Product Change Notification

Product Change Notification: P-22-021973

0.5FH 220pos 8H plug connector

Hard Tray change

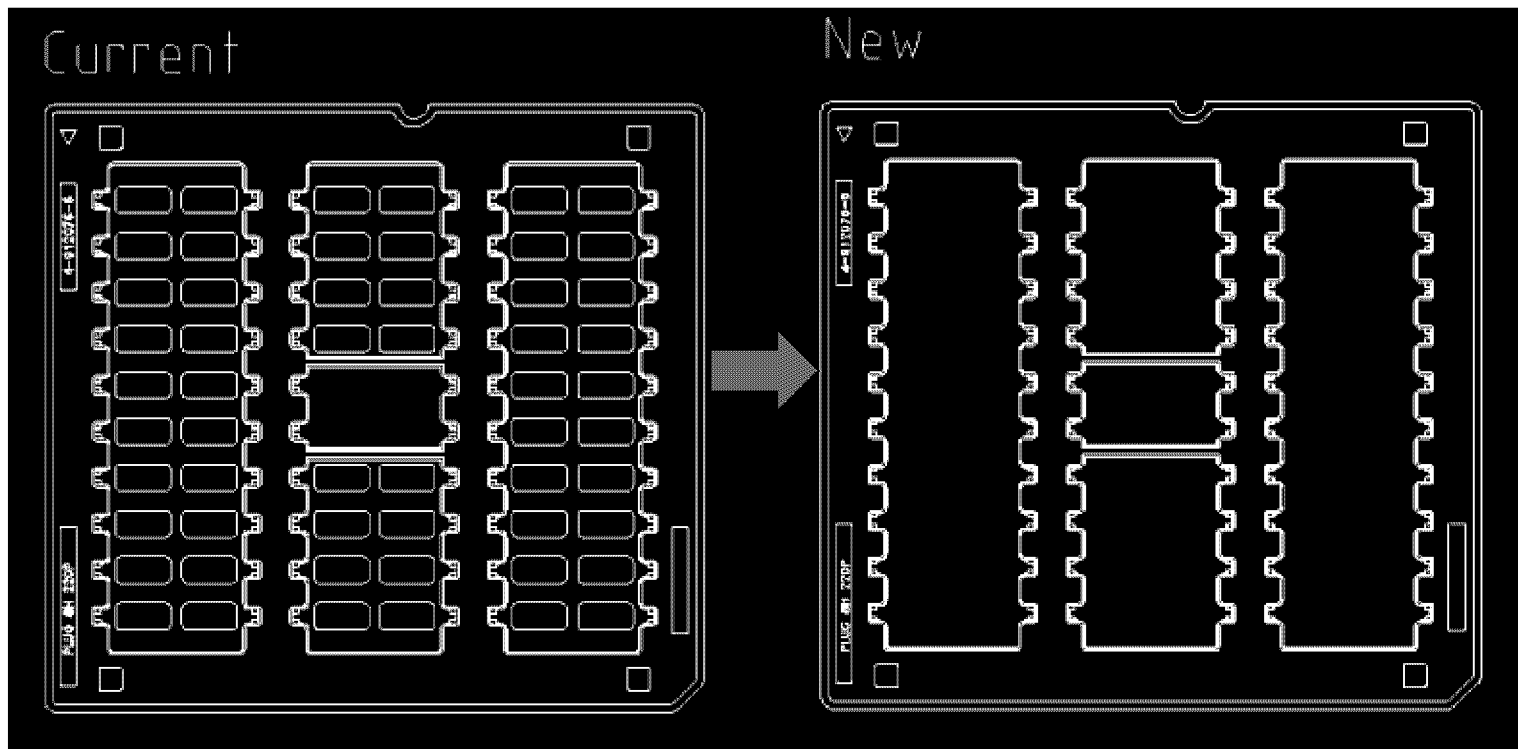
Hard Tray change that remove all holes of tray

Product improvement.This is a package optimization that to reduce the risk of pin deformation when operator take the hard tray by hand .

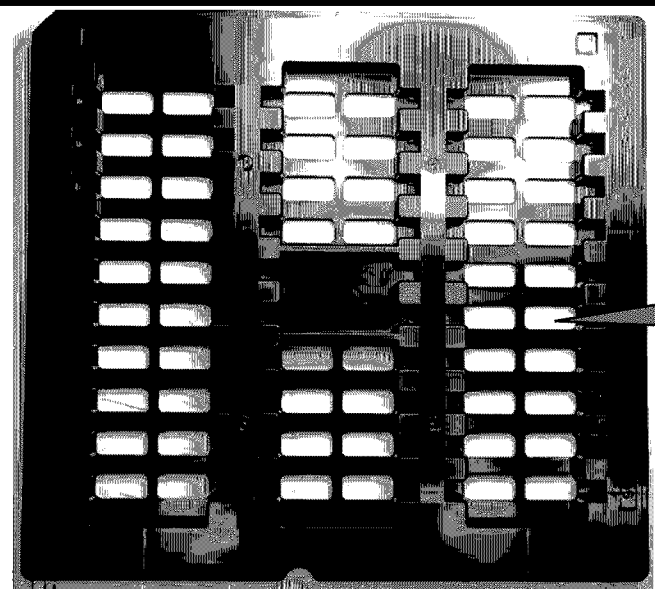
Only Remove all holes of Tray
